From: Melissa Balk <mbalk@davidsonsgroup.co.uk>
Sent: 01 September 2023 17:08
To: Lesley Keal
Cc: Sian Williams
Subject: RE: 23/00618/DISCON - Waste & Recycling C32
Attachments: BURB_100_ Planning Layout (Sheet 1) - Rev P04.pdf

Development:
**Land East Of Lutterworth Road
Burbage**

Drawing Ref:
Planning Layout (Sheet 1)

Drawing Status:	Planning	Drawn:	CS	Checked:	MS
Date:	June 2022	Scale:	1:500	Signed Off:	IP
Job Ref:	BURB_100

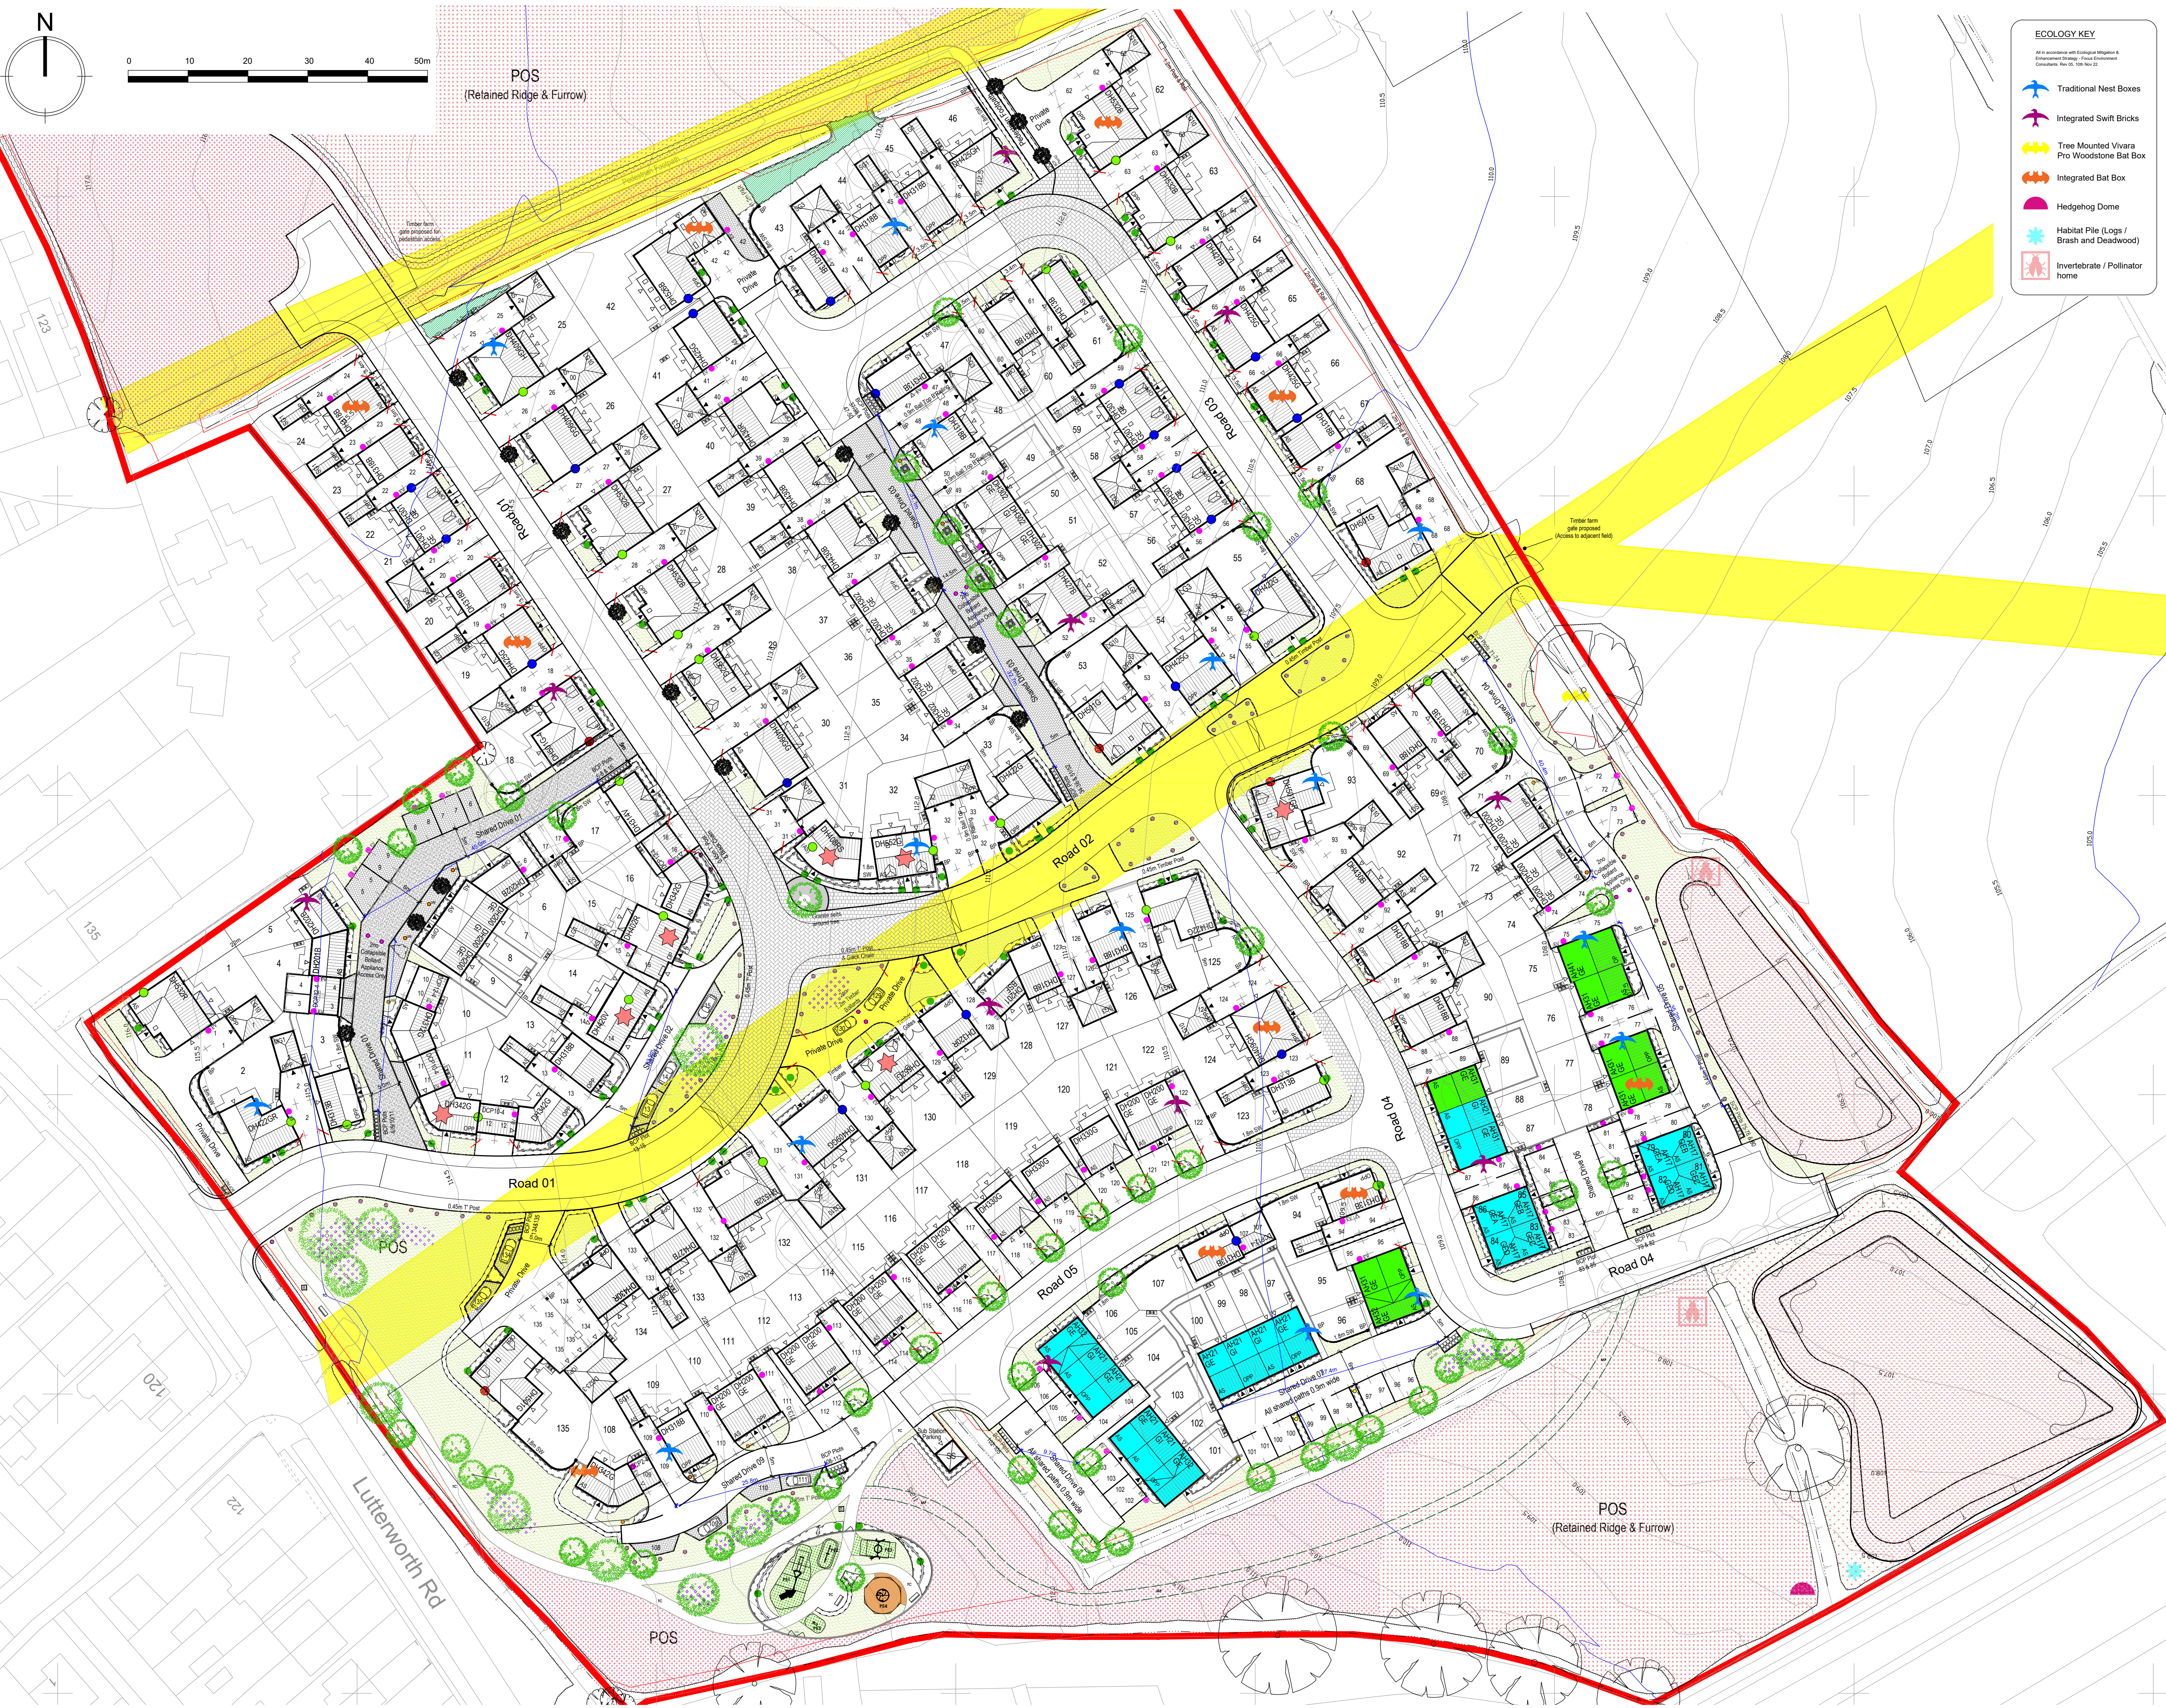
- Please can you add to the key – Bins – Bin Storage Points (so it is clear that they are not to be stored at collection points)
- Add Plots 1 & 2 collection points

- Detail plots to be collected from the highway boundary (adopted roads only)
- Plot 5 BCP ?
- Plot 62 BCP?
- Opposite Plot 96 is a BCP but is not clear what plots this will be (even if I magnify the plan) please make this clearer.
- Note on plant to confirm that bin collection points are only to be used on allocated collection days and are not for storage purposes.

- Please can you add to the key – Bins – Bin Storage Points (so it is clear that they are not to be stored at collection points) 'Bin Storage Area' added to key.

- Add Plots 1 & 2 collection points I have added a BCP for plot 1. Plot 2 fronts the highway so does not require a BCP.
- Detail plots to be collected from the highway boundary (adopted roads only) Plots 2, 12, 16-33, 39-46, 53-61, 63-70, 79, 82-95, 106, 107, 113-134

- Plot 5 BCP ? Plot 5's BCP is outside of plot 17 – no changes required to plan
- Plot 62 BCP? I have added a BCP for plot 62.
- Opposite Plot 96 is a BCP but is not clear what plots this will be (even if I magnify the plan) please make this clearer. I have relocated the text so it can be read – the BCP is for plots 96-101

- Note on plan to confirm that bin collection points are only to be used on allocated collection days and are not for storage purposes. I have added a note on the key under the 'Bin Collection Points'.

P04	BCP added for plots 1 & 62 and key updated to show bin storage area as per case officer comments.	01.09.2023
P03	Landscaping updated. Ecology items added to layout and Legend. Construction references (4) removed from layout and Schedule.	28.02.2023
P02	Drawing amended to reflect consultant comments.	23.09.2022
P01	Drawing finalised.	16.06.2022
Rev	Description	Date
